Abstract

The design of a daisy chain battery system, while fairly straightforward, has a number of design elements that can become obstacles to implementation. This case study provides a glimpse into the questions and responses in the development of one daisy chain system.

Introduction

FIGURE 1. INITIAL VBAT CONNECTION

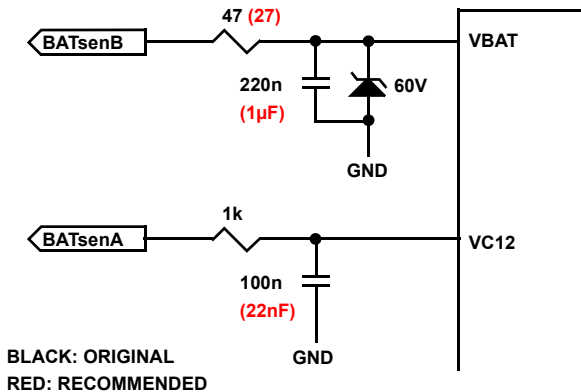
The VBAT input resistor was not damaged. Attached is a schematic of the VBAT connection.

Normally, we recommend a 27Ω resistor. While a 47Ω resistor may be OK, what happens is that the voltage at the VBAT pin drops when there is higher current, like during SPI or daisy chain communications. If the voltage drops too much, then there is not enough headroom on the front end analog circuits and there can be measurement errors. So, if the input resistor is not damaged then try a 27Ω resistor to see if this makes a difference.

If a smaller resistor value does not make a difference, then check that there is no large voltage differential across the VBAT series resistor. There should be a small drop in voltage (up to

about 80mV), however, if there is more than this, check the diode. If the diode is OK and there is still a voltage drop across the resistor, then the part may be damaged.

The schematic shows two connections to the top of the stack, one for VBAT and one for VC12. This is OK, however, check to see if there is a fault condition. If the BATsenB wire is broken, it could affect the measurement accuracy, however, this would also show up as an open VBAT fault.

Another recommendation we make on the input filters is that the time constants on all inputs be the same (or about the same). In this case, the cell input time constant is about 16 times the VBAT time constant. If there are high voltage transients on the pack voltage, the differential time constants will result in high voltage differentials on the IC input pins. To minimize this, we recommend different filter values, as shown in RED in [Figure 1 on page 2](#).

FIGURE 6. CUSTOMER ORIGINAL DAISY CHAIN CONTROL CONNECTIONS

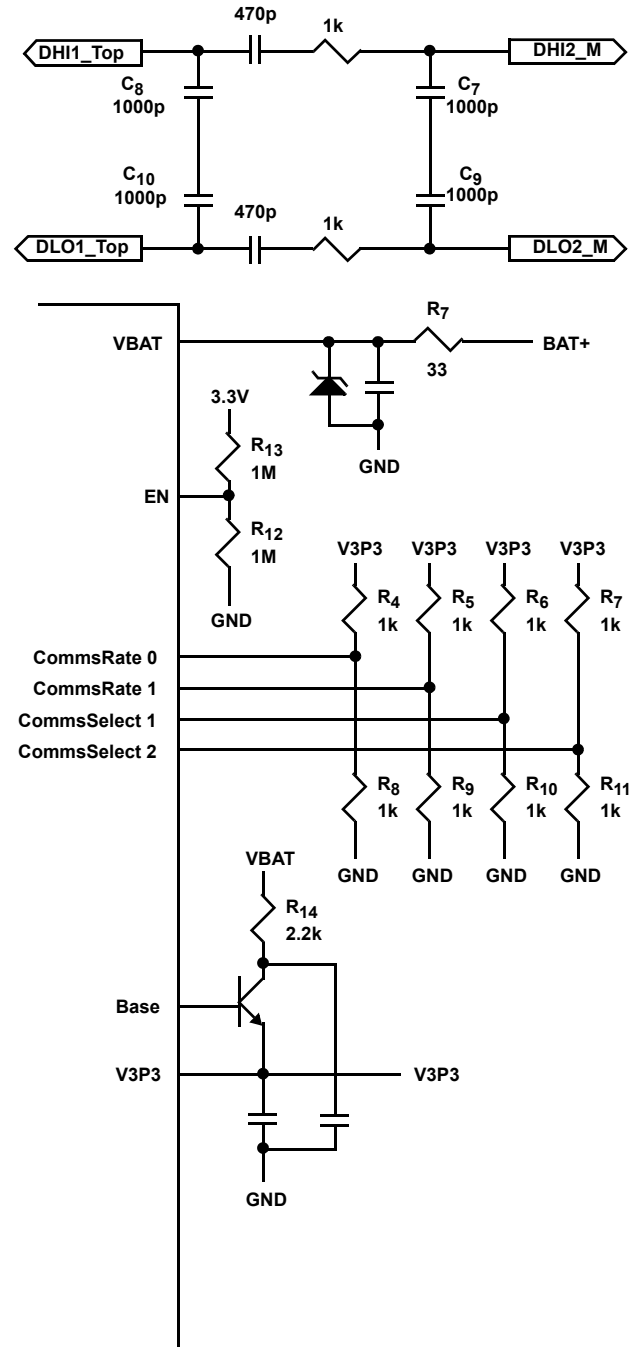
Below (Figure 6) is a schematic of the ISL78600 daisy chain and control circuits in my battery management system.

Resistor R_{12} is not loaded and the Comms pull-up/pull-down resistors are loaded according to the configuration settings above. I measured the voltage across the resistor, R_7 , in the schematic. The master bottom device is currently reading 11.9mV (360μA) and the top device is currently reading 2.4mV (72μA). Neither of these currents are popping off the datasheet to tell me what is going on.

The first thing to notice on the schematic is that the center point of the capacitors C₈ and C₁₀ (and C₇ and C₉) should be at the respective IC GND (see [Figure 7](#)).

1. Resistor R₁₄ is probably too big. This will work OK for stand-alone, however, because of higher currents in the Daisy Chain mode, it might cause the 3.3V supply to drop out during communications. In our designs, we use a 100 Ω resistor.
2. On the V3P3 regulator, the collector resistor R₁₄ is shown to connect to VBAT. This should connect to BAT+, otherwise the V3P3 current will also flow through R₇, reducing the VBAT voltage.

The observation that current across R₇ is only 360 μ A indicates that the device thinks it is a stand-alone device (i.e., Comms Select pins both at 0). Please check this.

FIGURE 8. CUSTOMER REPORTED CORRECT STAND-ALONE COMMUNICATION

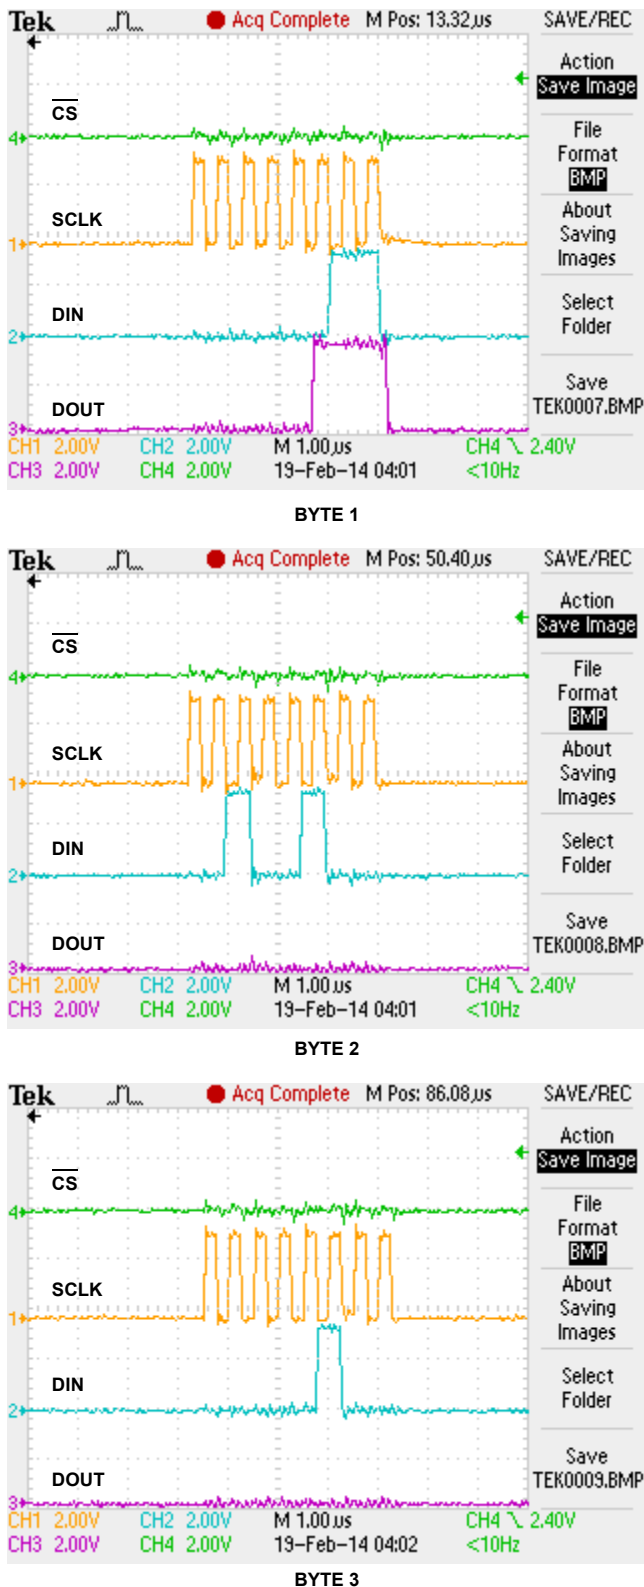
[Figure 8 on page 9](#) shows the SPI Identify command. The MISO data looks like 0x070000 but that's nothing valid to the best of my knowledge. If I send this command a few times in a row, I can get the MISO data to be 0x133800, which looks like a Comms Failure to me.

A: The fact that the upper device does not recognize the sleep/wake commands and there is no movement on the daisy chain lines means that there is something wrong with the daisy chain. *Nothing else matters until this can be cleared up.*

FIGURE 10. CUSTOMER DHI/DLO TRACES

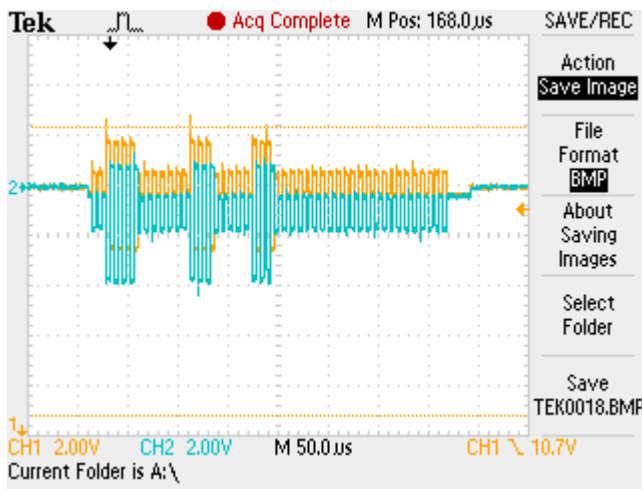
So, that looks good. [Figure 10](#) is the scope waveform for the master/bottom device's DHI2 and DLO2 lines, which actually look correct now while the daisy chain interface isn't connected. DLO2 is blue and DHI2 is orange.

The issue is that when I connected to the boards via the two daisy chain wires, the voltages on the master/bottom devices DHI2 and DLO2 go up to about ~22-23V.

A: The waveform in [Figure 10](#) looks almost correct for daisy chain communications, however, it is still not what you want to see. When the boards properly connect, you should see that the waveforms are more symmetrical vertically; and before and after the signals there should be an offset between the two traces (while here they appear to be the same voltage).

Since the voltages appear good before connecting the daisy chain wires, it looks like there is an isolation problem. Perhaps DHI2 and DLO2 on the top device are being connected to the DHI2 and DLO2 of the bottom device when you connect the two boards with the daisy chain wires. If so, then this would absolutely be a bad thing.

Check to make sure the top and bottom boards are completely isolated. Nothing on the top board should touch the bottom board, except the VSS of the top tying to the BAT+ of the bottom and the communications through the capacitors. The DHI2/DLO2 on the top board should be floating.

FIGURE 11. RECOMMENDED DAISY CONNECTIONS BETWEEN SEPARATE PCBs (COMPONENTS SELECTED FOR 500kHz DATA RATE)

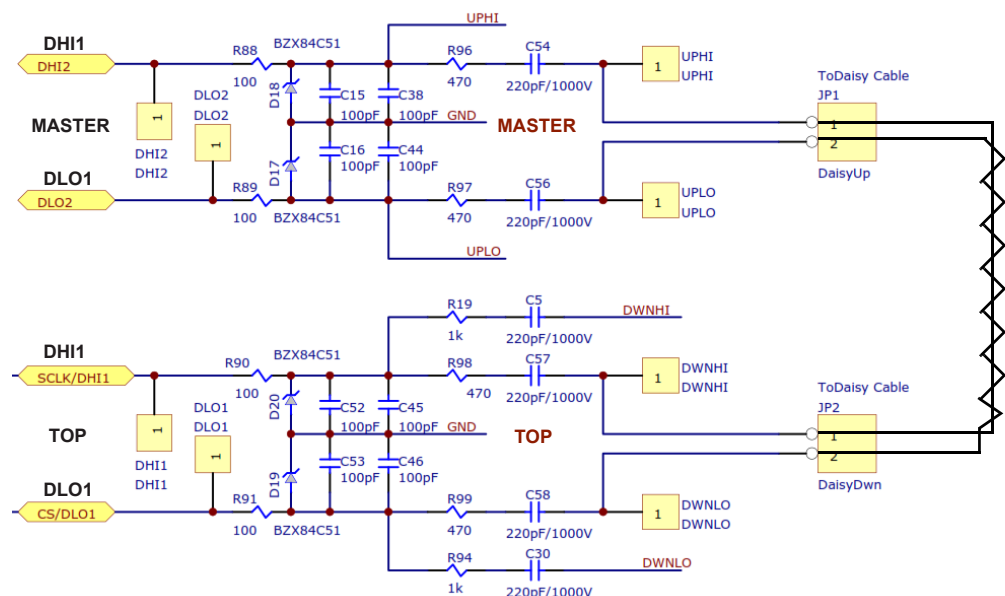
One other recommendation, if you have two boards connected by a cable, we normally recommend a daisy chain connection as shown in [Figure 11](#). This has components for faster daisy chain, however, what you might notice is that the up and down circuits are the same. This arrangement splits all of the components for symmetry, so if there is a break in the cable, the pins are isolated on both sides of the break. Even with a direct connection, this arrangement means that you do not need to bring the ground on the high side capacitors through the connector.

FIGURE 12. CUSTOMER DAISY WAVEFORMS AFTER CHANGES (GOOD)

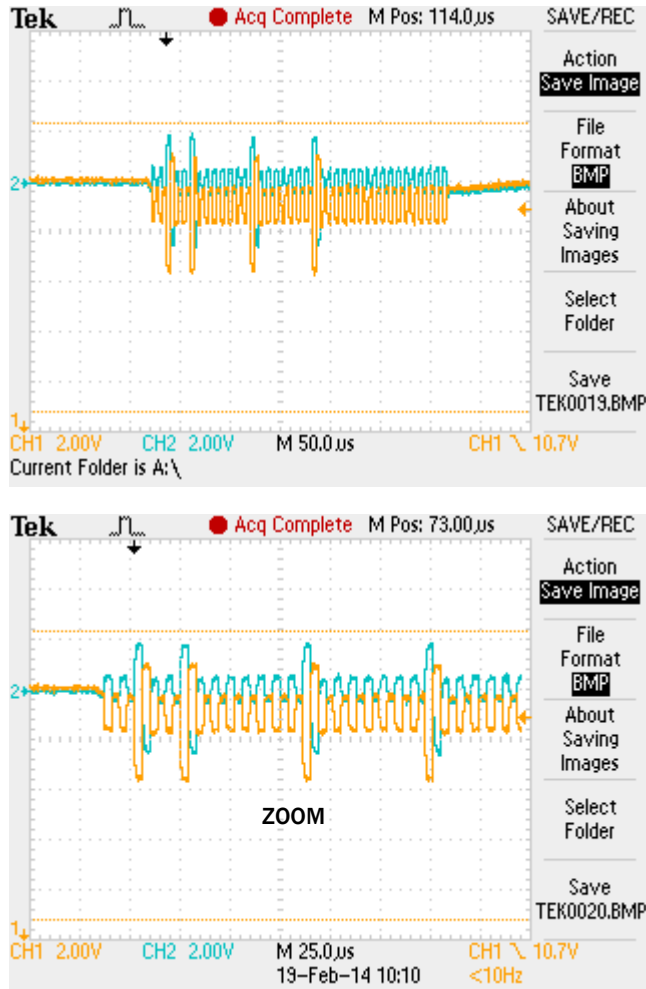
Q: Wow, it's been a long day. I think I finally got it right, however, I won't be able to check if valid data is coming back down the stack until tomorrow. [Figure 12](#) are two waveforms showing my daisy chain communication. What I sent you last time was just the master/bottom side, since connecting them had the isolation issue I described. Once I fixed the isolation issue, I connected the 2-wire daisy chain interface and captured the attached waveforms.

A: This looks better.

FIGURE 13. CUSTOMER BASE ID COMMAND (SPI)

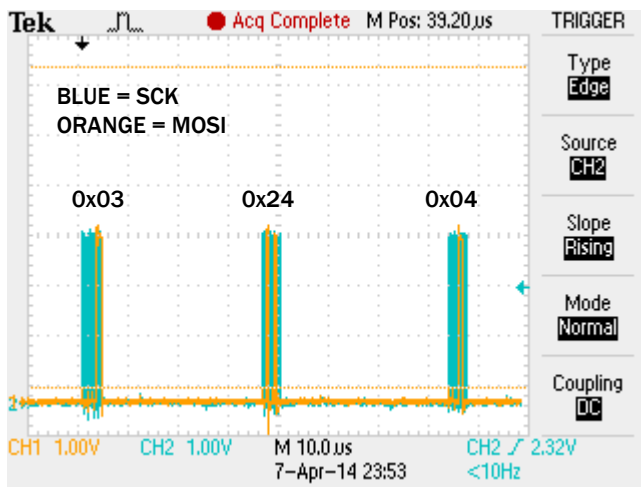
The 'base id command' waveform (Figure 13) shows the transmission of 0x03 24 04 from the Host MCU to the bottom/master device, specifically, the timing between SPI bytes in the overall transmission of this command. The timing shows that this command meets the 100μs maximum requirement defined as the $\overline{CS}$ high time (the time between bytes). Please let me know if you see any concerns with the timing of my command transmission.

A: In response to your last question first, bringing $\overline{CS}$ high between bytes is the proper way to send data.

I went through some timing diagrams from tests I did a while ago and found a scope shot of an identify sequence from our board. See [Figure 16](#). You can see that our response to data ready (the "0" trace) is much faster than yours and is about 3-4 μ s delay from falling edge of data ready to the start of SPI communication.

FIGURE 14. CUSTOMER DATA READY RESPONSE HANDLING TIMING

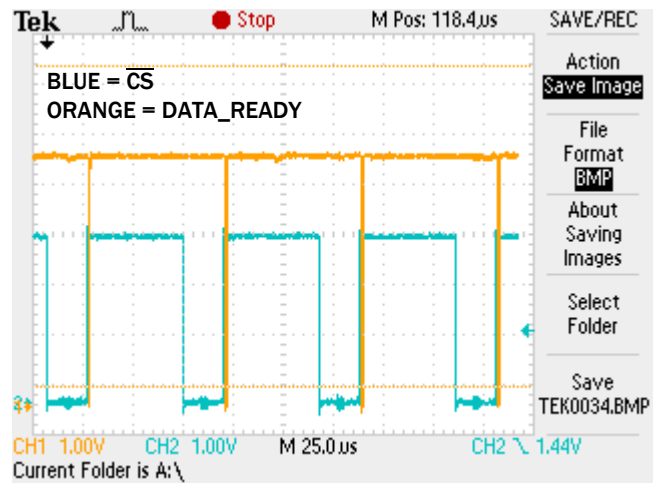
Also, the 'data_ready response handling' waveform (Figure 14), shows the timing on servicing the $\overline{DATA_READY}$ line. Please note that I have a level shifter that inverts $\overline{DATA_READY}$ from the ISL78600. As shown in the waveform, the $\overline{DATA_READY}$ signal goes HIGH when a byte is available in the ISL78600 buffer. The time that $\overline{CS}$ is low is the time it takes for me to read a SPI byte (~25μs). At the completion of each read with the rising edge of $\overline{CS}$, you can see $\overline{DATA_READY}$ dip low briefly and return HIGH, indicating another byte is available. The time from the rising edge of $\overline{DATA_READY}$ to $\overline{CS}$ going low again is the time it takes for me to respond to the $\overline{DATA_READY}$ signal (~45-50μs). Do you think this is too long?

Note: Our initial answer to this question is as follows: "We worked with our designers and got simulation results for the $\overline{CS}$ to SCLK timing. As it turns out, there is a maximum time from the falling edge of $\overline{CS}$ to the first rising edge of SCLK. This only shows up on the IDENTIFY command, not on any other command. Simulations show that there can be data corruption in the IDENTIFY response if the $\overline{CS}$ to SCLK time exceeds 50 μ s. We will be changing the datasheet to include a comment suggesting a maximum of 30 μ s (to cover corner conditions) between these two signal edges."

However, additional relevant information is now included in the datasheet found in a Section Titled "Daisy Chain Transmit Buffer". The following is the section repeated.

A 4-byte data buffer is provided between the SPI and Daisy Chain communications. A command sent on the SPI port is passed to the Daisy Chain, starting two Daisy Chain clock cycles after the rising edge of $\overline{CS}$ (at the end of the first byte of the command). The Daisy Chain then clocks data out of the transmit buffer.

IMPORTANT: The host microcontroller must continue to feed the buffer with command bytes before all bytes have been clocked out on the Daisy Chain. If the Host MCU cannot keep the buffer full with proper command bytes, the Daisy Chain sends bad data to the devices on the Daisy Chain. This results in the Daisy Chain device receiving a command with a bad CRC and that device responds with a NAK.
